# Grinnell®

Assignment 98-81                      Supplement to Submission

## Environmental Assessment

Please provide the following information to complete your amendment application for NR-776-D-101-E.

Figure 1

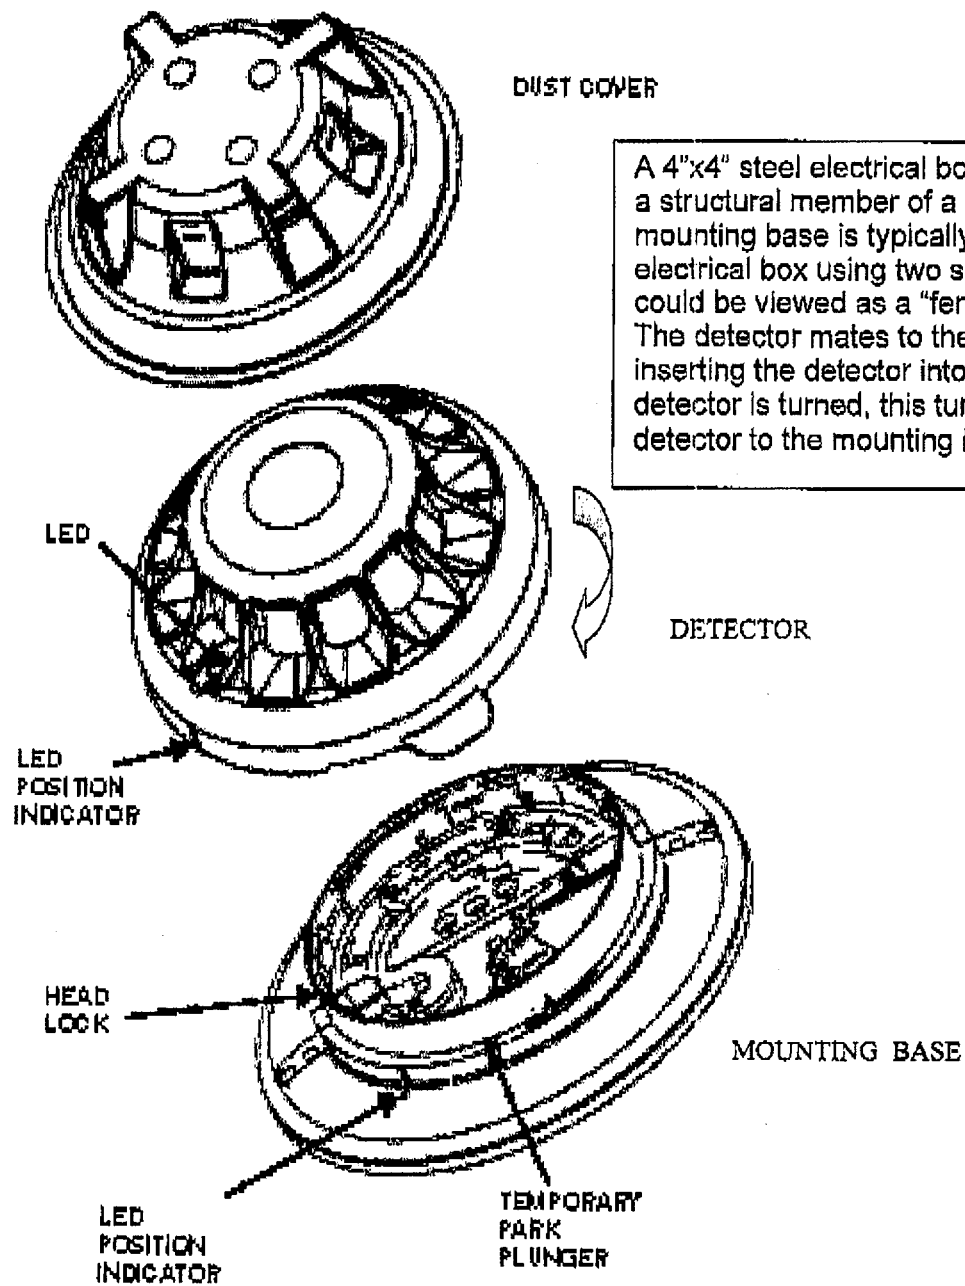
1. You stated in the application that the MF series and Nittan detectors are no longer manufactured and the personnel who filed the documents are no longer with the company. Therefore, I'll convert current NR-776-D-101-E into inactive status and issue new registration certificate for Lo-Pros series 612I and 912I detectors.
2. Please explain the terms for "addressable smoke detector" and "non-addressable smoke detector."
3. Please provide more detailed explanation for "... in plug in bases." What kind of plug is used? The drawing does not show the plug.

A 4"x4" steel electrical box (not shown) is secured to a structural member of a ceiling or wall. The mounting base is typically installed onto the steel electrical box using two screws. The mounting base could be viewed as a "female" outlet for the detector. The detector mates to the mounting base. After inserting the detector into the mounting base, the detector is turned, this turning motion secures the detector to the mounting base.
